TSG-RAN Working Group 1 meeting #11  
 San Diego, CA, USA  
 February 29 – March 3, 2000

**TSGR1#11(00)0349**

**To:** RAN WG2  
**Source:** RAN WG1  
**Title:** Liaison on Proposed updates to TR 25.926

**Figure 1: UE transport channel processing limitations in downlink TO BE UPDATED**

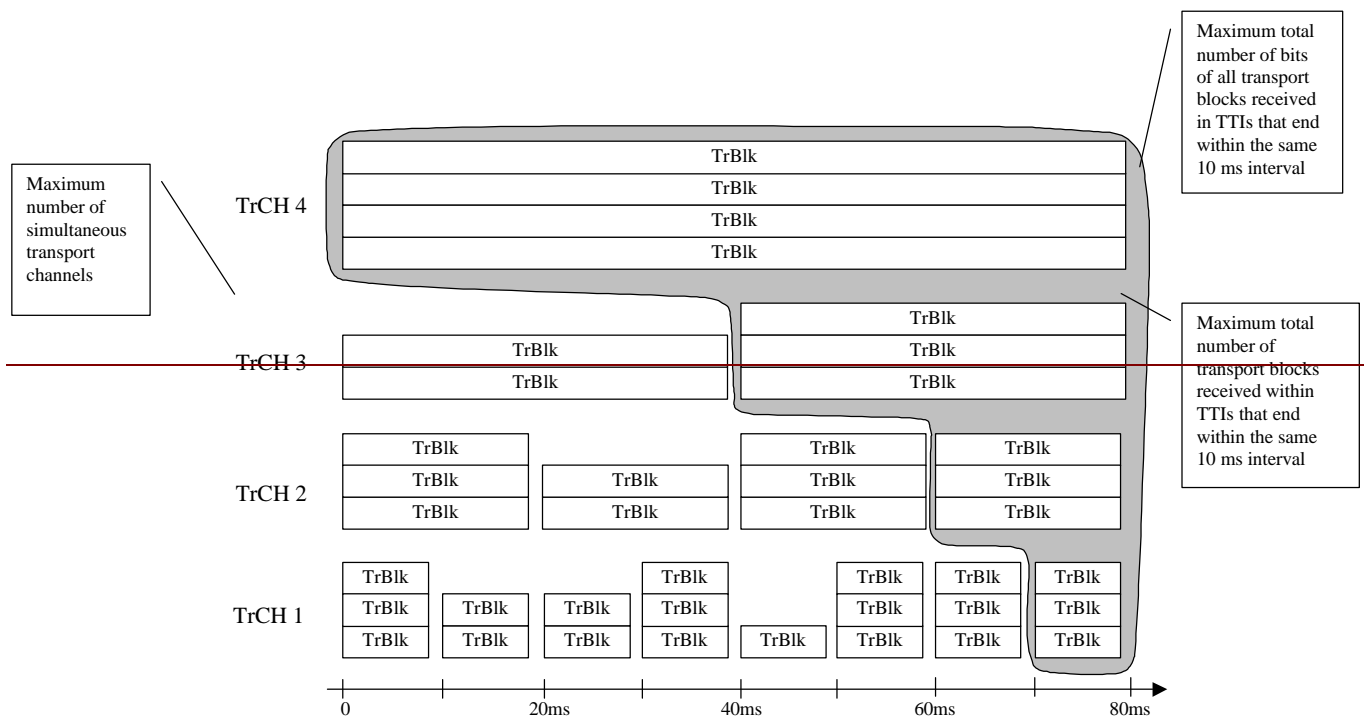
~~This parameter is related to memory requirements for received downlink data before it is delivered to MAC. As shown in Figure 1 the worst case occurs for the maximum TTI.~~

~~NOTE: It has been noted that the current definition does not cover the case where TTIs on simultaneous DCH and DSCH are not aligned.~~

**Maximum sum of number of bits of all transport blocks received in TTIs that end within the same arbitrary interval of length T<10 ms.**

where  $N_i$  is defined as the number of bits in transport block #i, and the sum is over all transport blocks received in TTIs that end within the same 10 ms interval. All transport blocks that are to be simultaneously received by the UE on DCH, FACH, PCH and DSCH transport channels are included in the parameter.
